Access Compliance Report

Public Rights-of-Way

(Curb Ramps)

Intersection ID: 51323	Main Street: GLENMORE_GARDEN_DR	Cross Street: MCKEE_RD	Location: NE
ADA ID: 73B4F7FDC139	Ramp Type: Perp	Initial Pass/Fail: Fail	Overall Compliance: No
Severity Score: 8.75			
Codes/Mitigation Info/Possible Solution		Field Measurements/Component Compliance

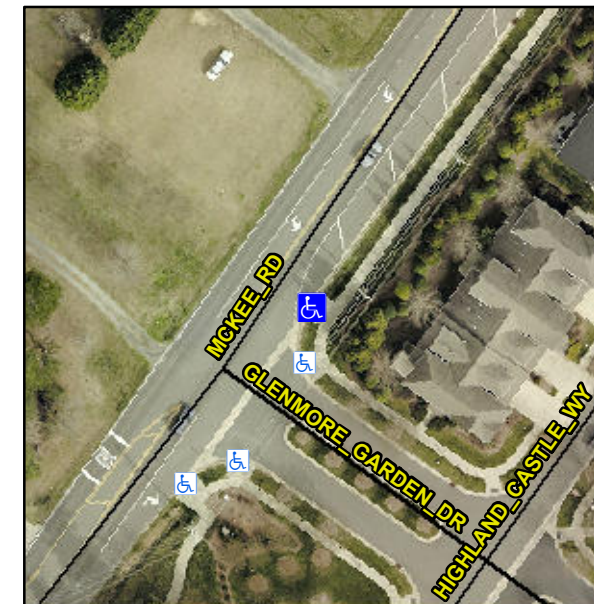
Not Found, R304.5.1

Compliance	Description	Data	Compliance	Description	Data
N/A	Ramp Length (in)	96.0	Yes	Ramp Slope (%)	6.1
No	Ramp Width (in)	45.0	Yes	Ramp XSlope (%)	2.0
N/A	Flare Type LT	N/A	N/A	Flare Type RT	N/A
N/A	Flare Slope LT (%)	N/A	N/A	Flare Slope RT (%)	N/A
N/A	Flare Traversable LT?	N/A	N/A	Flare Traversable RT?	N/A
N/A	Landing Length (in)	N/A	N/A	DWS Provided?	N/A
N/A	Landing Width (in)	N/A	N/A	DWS Contrast?	N/A
N/A	Landing Slope (%)	N/A	N/A	DWS Length (in)	N/A
N/A	Landing X Slope (%)	N/A	N/A	DWS Full Width?	N/A
N/A	Landing Curb? (Y/N)	N/A	N/A	DWS Offset (in)	N/A
N/A	Shared Landing?	N/A			
N/A	Gutter Ponding?	N/A	N/A	Gutter Slope (%)	N/A
N/A	Gutter Lip Ht (in)	N/A	N/A	Gutter X Slope (%)	N/A
N/A	Painted X Walk1?	No	N/A	Painted X Walk2?	N/A
	X Walk 1 Direction	To NW		X Walk 2 Direction	N/A
N/A	X Walk 1 Width (in)	N/A	N/A	X Walk 2 Width (in)	N/A
	X Walk 1 Slope (%)	2.2		X Walk 2 Slope (%)	N/A
	X Walk 1 X Slope (%)	1.3		X Walk 2 X Slope (%)	N/A

Remove & Replace Entire Ramp.
